# Access Compliance Report

## Public Rights-of-Way

Intersection ID: 15179	Main Street: DRESDEN_DR_EAST	Cross Street: WESTCHESTER_BV	Location: NE
ADA ID: A1D5D513948F	Ramp Type: BlendTrans1	Initial Pass/Fail: Fail	Overall Compliance: No
		Severity Score: 10

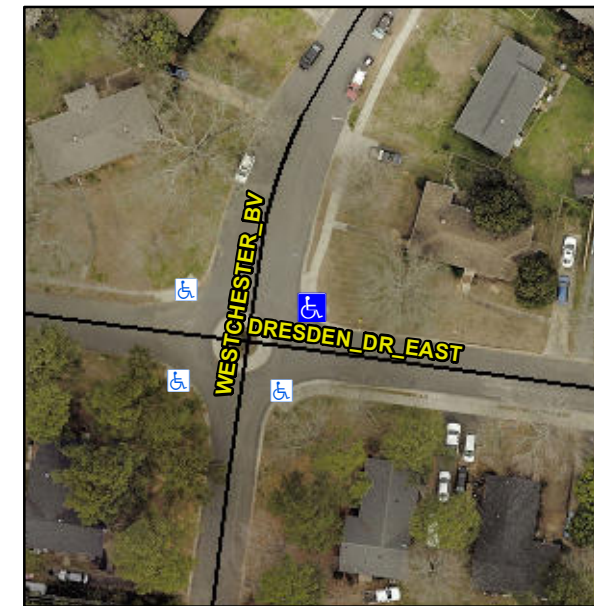
**NO RT SW**

**Not Found, R304.5.1, R304.5.3**

**Remove & Replace Curb Ramp With Two New Directional Ramps or Equivalent.**
